INFORMATION LETTER

206L-21-103

SUBJECT: THROTTLE CABLE ASSEMBLY 1608750-001, INTRODUCTION OF.

Figure 1 – Example of Failed Throttle Cable Assembly

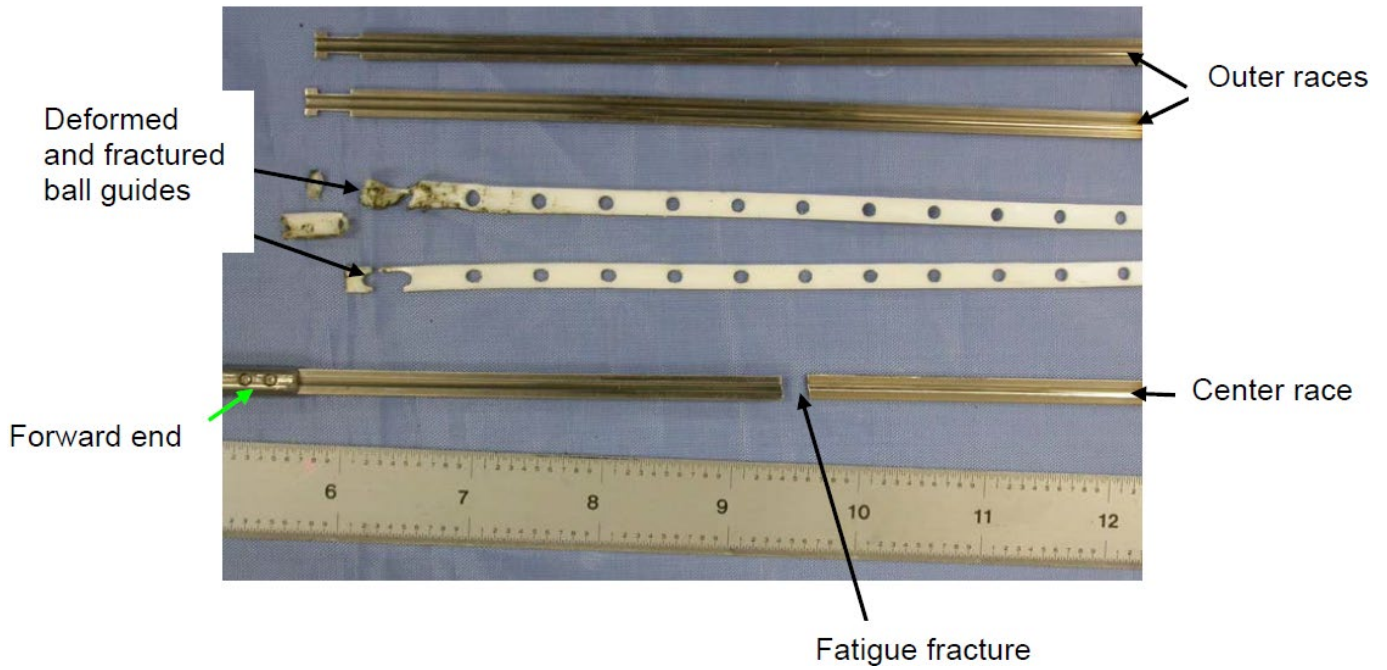
Following root cause investigations, several locations of the fractures of the center race material (Figure 1) occurred due to fatigue cracks that propagated over time. The majority of the failures occurred at the first bend under the pilot seat (Figure 2). During installation of the throttle cable assembly, it was noted that in certain areas the throttle cable assembly could have high stress loads applied, or kinked, while routing the cable assembly through the various areas of the airframe structure where the cable assembly could be exposed to high bend radii.

Figure 4 – Throttle Cable Assembly 1608750-001 Design Improvements (206L4 Installation Shown as Reference)

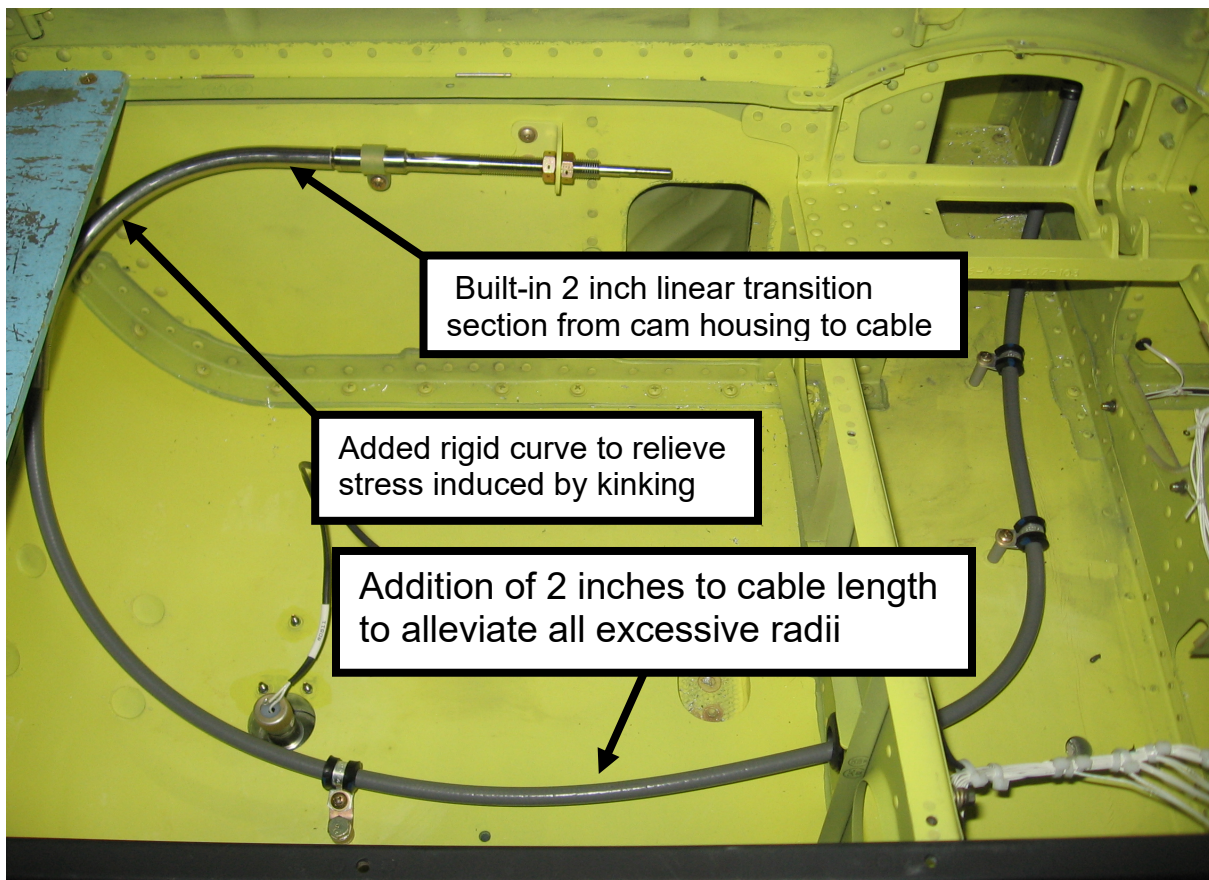
To minimize the possibility of future throttle cable assembly failures, Bell introduced the throttle cable assembly 1608750-001 into the production configuration of the 206L4 at serial number 52449 through 52496. In conjunction with the new design (Figure 4), improved installation procedures, revised rigging procedures, and handling procedures

were incorporated to the applicable sections of the respective Maintenance Manuals (Chapter 76).
